MIL-A-22165 (WEP)
AMENDMENT-5
15 MAY 1961
SUPERSEDING
AMENDMENT-4
1 MARCH 1961

MILITARY SPECIFICATION

AMPLIFIER, COMPASS, SERVO (TYPE MF-1 COMPASS)

This amendment forms a part of Military Specification MIL-A-22165(Aer) of 15 August 1959, and has been approved by the Bureau of Naval Weapons, Department of the Navy.

Figure 1
Compensated and Uncompensated Dials and Vernier

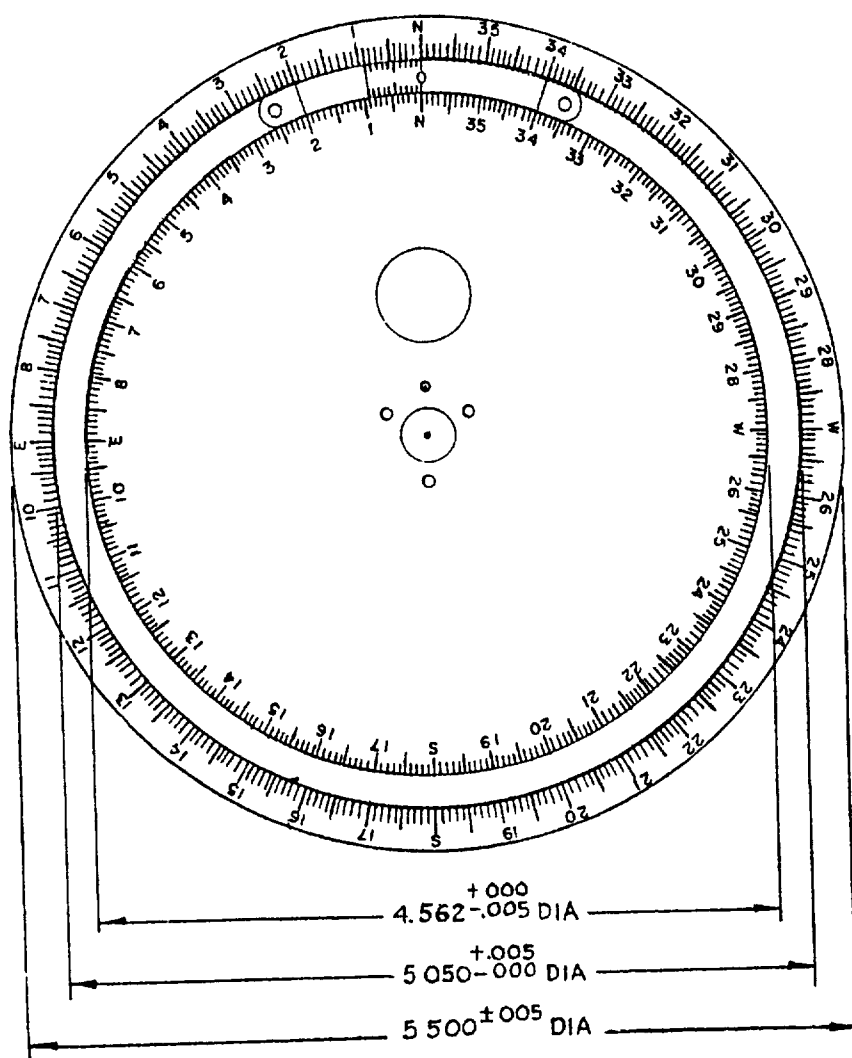
Page 4: Paragraph 3.12 Dial Marking.- Add the following sentence and table to the end of this paragraph:

Page 5: Delete Figure 1 and substitute new Figure 1 attached.

"The dimensions of the dial markings shall be as follows:

Compensated Dial		Uncompensated Dial	
	Height or Length Inch	Wide Inch \pm .002	Height or Length Inch	Width Inch \pm .002
Numerals, Letters	.070	.012	.070	.012
10° Graduations	.125	.010	.094	.010
5° Graduations	.125	.006	.094	.006
1° Graduations	.078	.006	.062	.006

Vernier

Height or Length Inch	Wide Inch \pm .002
Numerals	.062	.012
"0" and "1" Graduations	.060	.010
6th Graduation	.060	.006
All others	.046	.006
